UNITED STATES
NUCLEAR REGULATORY COMMISSION
WASHINGTON, D.C. 20555-0001

SUBJECT: PALO VERDE NUCLEAR GENERATING STATION, UNITS 1, 2,
AND 3 - ISSUANCE OF AMENDMENT NOS. 212, 212, AND 212 TO REVISE
TECHNICAL SPECIFICATIONS TO SUPPORT THE IMPLEMENTATION OF
FRAMATOME HIGH THERMAL PERFORMANCE FUEL
(EPID L-2018-LLA-0194)

1. Amendment No. 212 to NPF-41
2. Amendment No. 212 to NPF-51
3. Amendment No. 212 to NPF-74
4. Safety Evaluation (Proprietary)
5. Safety Evaluation (Non-Proprietary)

Figure 1: Decomposing G - Main Goal

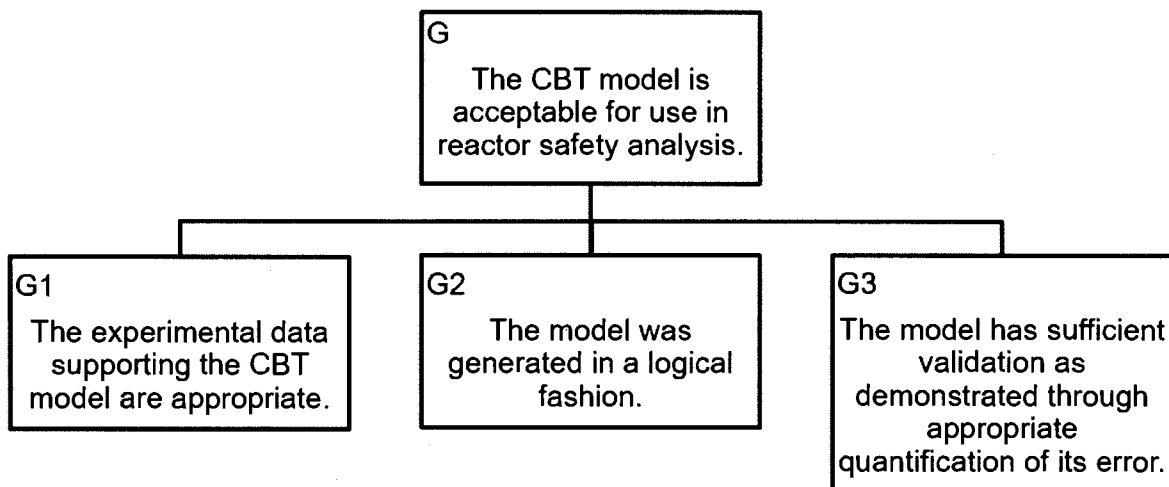
For CHF models, the main goal is: "The critical boiling transition (CBT) is acceptable for use in reactor safety analyses." Based on the NRC staff's experience reviewing these models, a study of previous SEs and SERs, and multiple discussions with various industry experts, this goal is decomposed into the three subgoals given in Figure 1 below.

The BHTP CHF model has already been approved, and therefore, the NRC staff has previously considered these three goals to have been met. Therefore, the implementation of the BHTP into VIPRE-W and VIPRE-APS would not impact the NRC staff's findings on G1 and G2, as those are independent of the computer code in which the model is applied. However, it would impact G3 as the model's error must be generated using a subchannel such as VIPRE. Therefore, the NRC staff will focus its review on ensuring that the validation of the BHTP CHF model does not change when applying the model with VIPRE-W and VIPRE-APS compared to the model's initial application with LYNXT (Reference 32).

Figure 2: Decomposing G3 – Model Validation

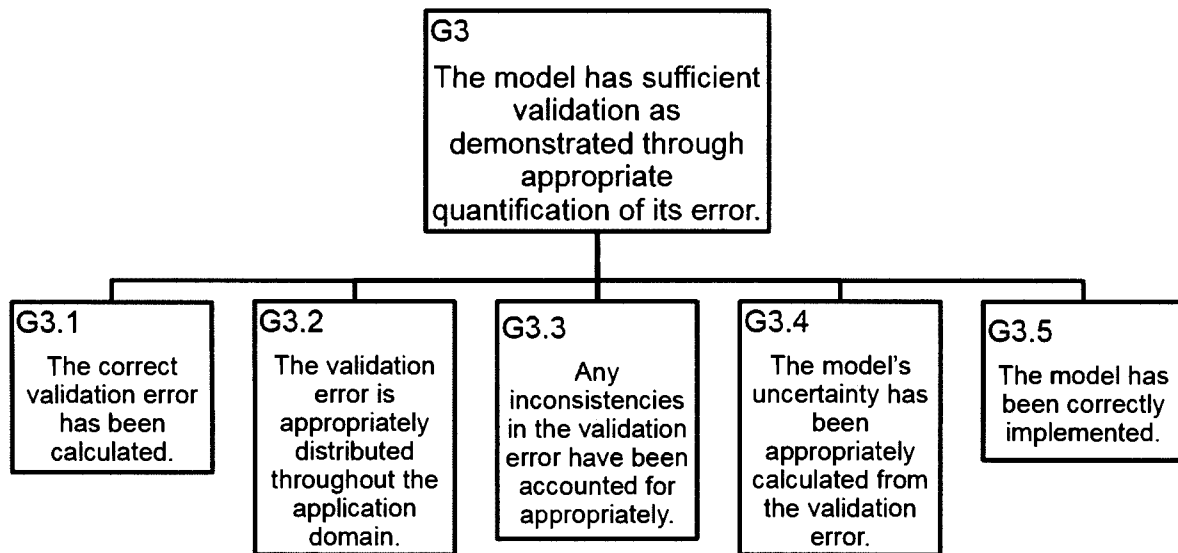
Validation is the accumulation of evidence, which is used to assess the claim that a model can predict a real physical quantity (Reference 61). Thus, validation is a never-ending process as more evidence can always be obtained to bolster this claim. However, at some point, when the accumulation of evidence is considered sufficient to make the judgment that the model can be trusted for its given purpose, the model is said to be validated. Demonstrating that the model validation is appropriate is accomplished by using the five subgoals given in Figure 2 below.

The validation error is obtained from a ratio of the measured CHF value and the predicted CHF value. However, there are method ways in which the measured and predicted CHF values could be determined. It is important that the same method (e.g., subchannel of lowest DNBR, subchannel where CHF was measured) was used in both the initial approval of BHTP and the applications of BHTP in VIPRE-W and VIPRE-APS. In response to BHTP RAI-01 by letter dated October 4, 2019 (Reference 5), APS stated that the test conditions are input into both versions of VIPRE and is input into the location of minimum DNBR. The heat flux in this subchannel was considered the “measured” value of CHF and the BHTP’s prediction at this subchannel was considered the “predicted” value. APS further noted that this method is consistent with the method used in the initial development of the BHTP. Because the method of calculating the validation error in both VIPRE-W and VIPRE-APS is consistent with the method of calculating validation error in the initial approval of BHTP (Reference 32), the NRC staff has concluded that this goal has been met.

Figure 3: Decomposing G3.2 – Data Distribution

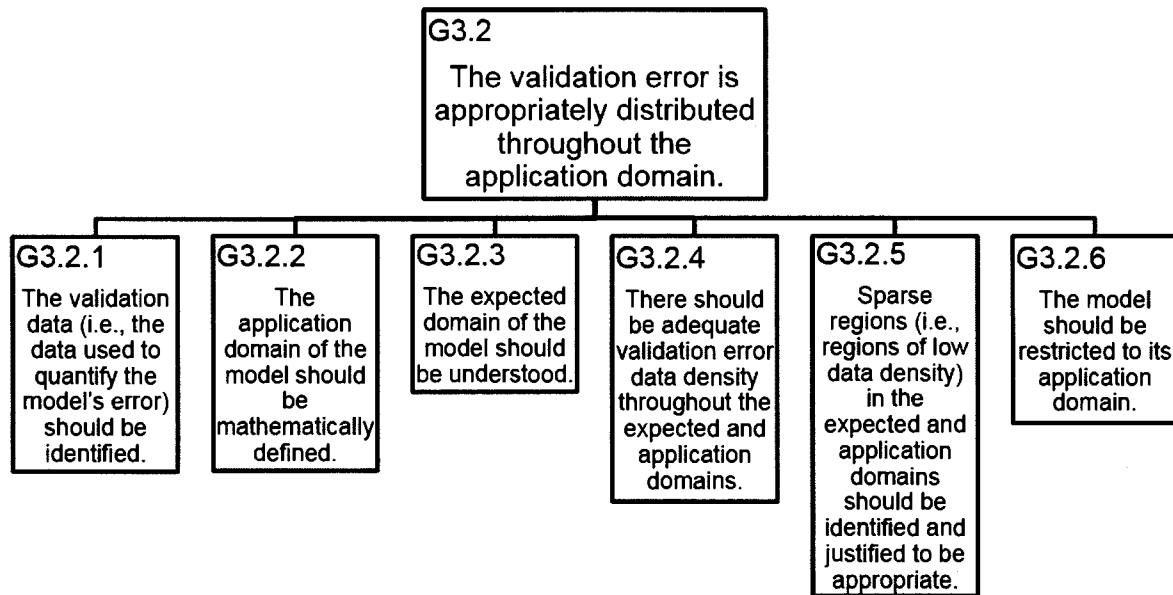
The second subgoal in demonstrating that the model’s validation is appropriate is to demonstrate that the data is appropriately distributed throughout the application domain. This is typically demonstrated using the six subgoals as given in Figure 3 below.

In general, the application of an approved CHF model into a new computer code should not impact the distribution of the validation error in the application domain, because that distribution is primarily determined by the experimental data used for validation. Therefore, instead of this section being focused on ensuring that the validation error is appropriately distributed, it is focused on ensuring that the application of the approved model into the new code did not change how the validation error is distributed.

In response to BHTP RAI-02 by letter dated October 4, 2019, APS confirmed that the same validation data used in the initial approval of BHTP was used in qualifying BHTP with VIPRE-W and VIPRE-APS. Because APS has identified the validation data, the NRC staff has concluded that this goal has been met.

Figure 4: Decomposing G3.3 – Inconsistencies in the Model's Error

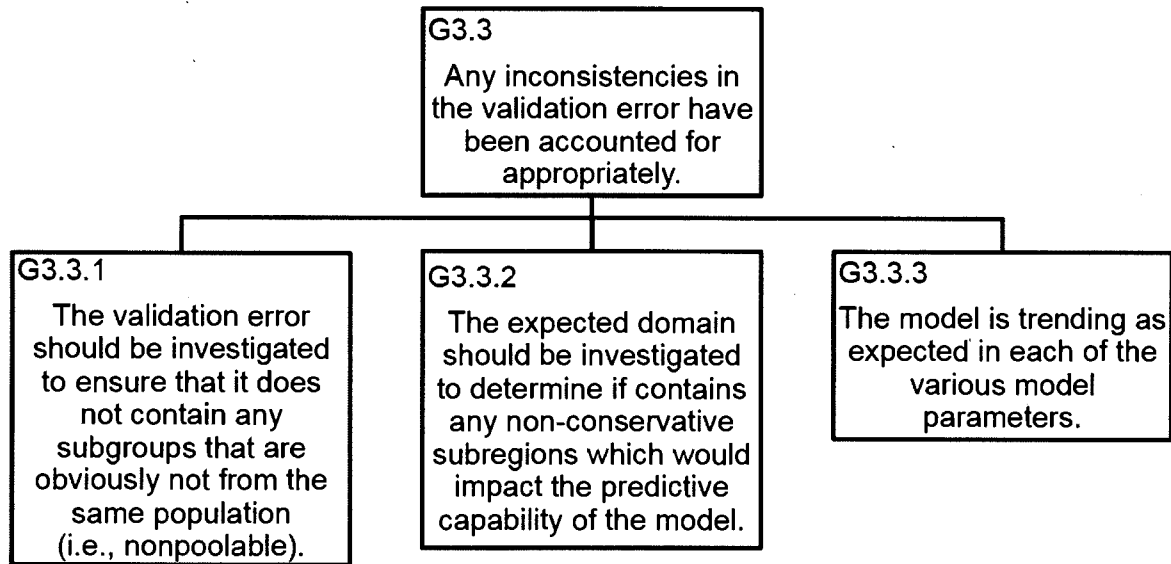
The third subgoal in demonstrating that the model's validation was appropriate is to demonstrate that the model error is consistent over the application domain. This is typically demonstrated using the three subgoals as given in Figure 4 below.

In response to BHTP RAI-05 by letter dated October 4, 2019, APS provided an analysis of the various subgroups in the BHTP validation data base. APS examined the main subgroups of [[

In response to BHTP RAI-06, APS provided an analysis, which demonstrated that the predictions of LYNXT and VIPRE were very similar and that both methods approximately predicted non-conservative CHF data points at the same input properties. Further, while the NRC staff was aware of the potential for a slight non-conservative subregion in the unit cell testing, the staff found that the magnitude of the potential non-conservative behavior of that region was very small and would be more than accounted for in other conservatism in the development and assessment of the BHTP model. Therefore, the NRC staff has concluded that this goal has been met.

Figure 5: Decomposing G3.4 – Quantified Model's Error

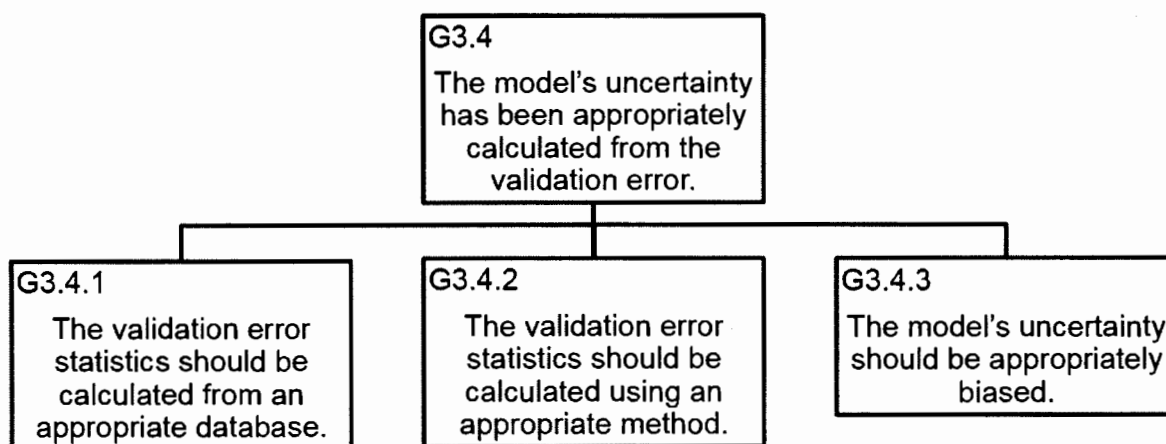
The fourth subgoal in demonstrating that the model's validation was appropriate is to demonstrate that the model error has been appropriately quantified over the application domain. This is typically demonstrated using the three subgoals as given in Figure 5 below.

data. This comparison also included the extended range of BHTP as discussed in the supplemental response to BHTP RAI-03 dated November 26, 2019. The BHTP CHF model conservatively predicted data in this extended range. Further, that data was not used in generating the statistical DNB limit of the CHF model as ignoring the data for the generation of that limit resulted in a more conservative limit. Because APS provided the validation, which demonstrates that BHTP conservatively predicts CHF in both VIPRE-W and VIPRE-APS, and that comparison confirmed the use of the initially approved DNBR limit for BHTP, the NRC staff has concluded that this goal has been met.

Figure 6: Decomposing G3.5 – Model Implementation

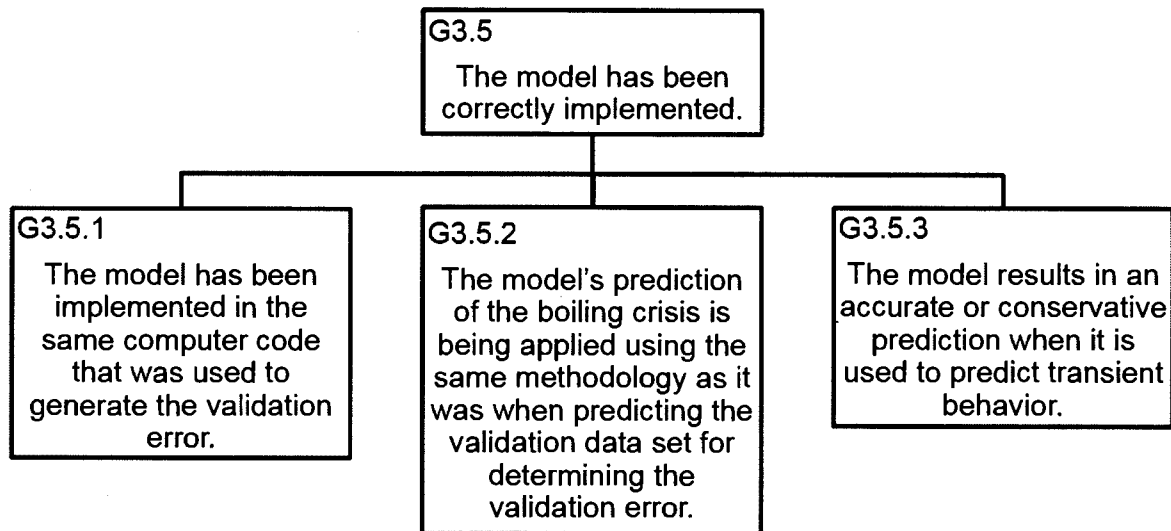
The fifth subgoal in demonstrating that the model's validation was appropriate is to demonstrate that the model will be implemented in a manner consistent with its validation. This is typically demonstrated using the three subgoals as shown in Figure 6 below.

For VIPRE-W, the BHTP model is being implemented in the VIPRE-W computer code, but with different model options (i.e., closure models) than were in the initial approval of VIPRE-W. Therefore, in response to BHTP RAI-09 by letter dated October 4, 2019, APS provided clarification that when BHTP was used in VIPRE-W, the modeling options used were those given in the LAR. While APS is not using the same computer code, it has re-validated the modeling options for BHTP in VIPRE-W (provided in response to BHTP RAI-07) and has demonstrated that BHTP used in VIPRE-APS and VIPRE-W results in the same predictions for the same input. The NRC staff finds that this re-validation and demonstration of results satisfies the intent of this goal. Therefore, the NRC staff has concluded that this goal has been satisfied for VIPRE-W.

The purpose of this part of the review was to revalidate the BHTP CHF model and how it is applied in the evaluation framework of VIPRE-W or VIPRE-APS. In response to BHTP RAI-10 in a letter dated October 4, 2019 (Reference 5), APS confirmed that future uses of the BHTP CHF correlation in either VIPRE-W or VIPRE-APS will be used in a manner consistent with that used when performing the validation analysis presented above. Therefore, the NRC staff has concluded that this goal has been satisfied.
